**Technical Service Bulletin (TSB)**  
**Flexplate Bolts Loose**

<b>REFERENCE:</b>	<b>TSB:</b> 09-012-25 <b>GROUP:</b> 09 - Engine	<b>Date:</b>	May 28, 2025	<b>REVISION:</b>	—
<b>VEHICLES AFFECTED:</b>	<b>2025 (DT) RAM 1500 Pickup</b> <b>2025 (WS) Wagoneer / Grand Wagoneer</b> This bulletin applies to DT vehicles built on or after March 21, 2025 (MDH 0321XX) and on or before April 17, 2025 (MDH 0417XX) equipped with either of the following: This bulletin applies to WS vehicles built on or after March 24, 2025 (MDH 0324XX) and on or before April 17, 2025 (MDH 0417XX) equipped with either of the following: <ul style="list-style-type: none"> <li>• 3.0L I6 Hurricane HO or SO Twin Turbo ESS (Sales Code EFC or EFH).</li> </ul>			<b>MARKET APPLICABILITY:</b>	
				<input checked="" type="checkbox"/> NA	<input type="checkbox"/> MEA
				<input type="checkbox"/> EE	<input type="checkbox"/> IAP
				<input type="checkbox"/> SA	<input type="checkbox"/> CH
<b>CUSTOMER SYMPTOM:</b>	Customers may experience the following: <ul style="list-style-type: none"> <li>• Noise coming from under the hood.</li> </ul>

**Fig. 1**  
Flexplate Bolts

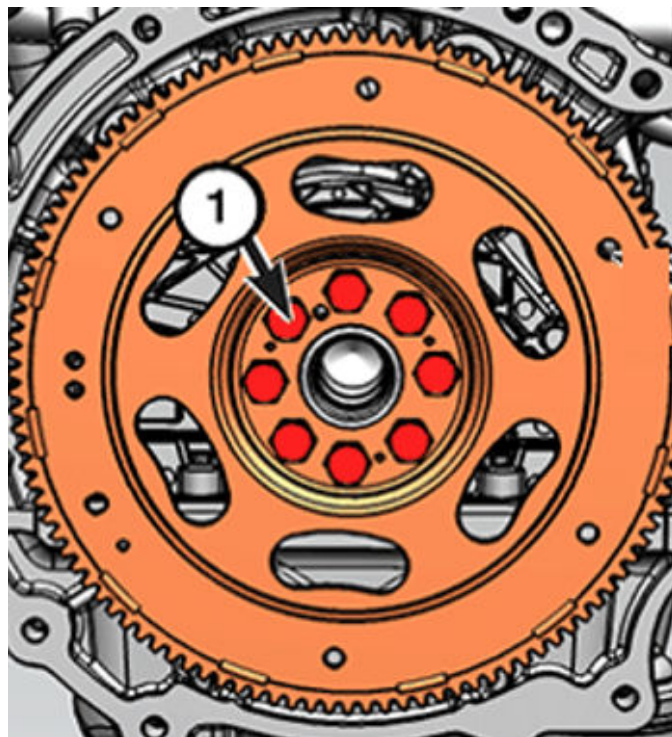
<b>CAUSE:</b>	Improper flexplate bolt torque

This bulletin involves replacing all flexplate to crankshaft bolts.

1. Replace all flexplate to crankshaft bolts [Fig. 1](#). Refer to the detailed service procedures available in DealerCONNECT/Service Library under: Service Info> 21 - Transmission and Transfer Case / Automatic - 8HP75 / Flexplate / Removal and Installation.
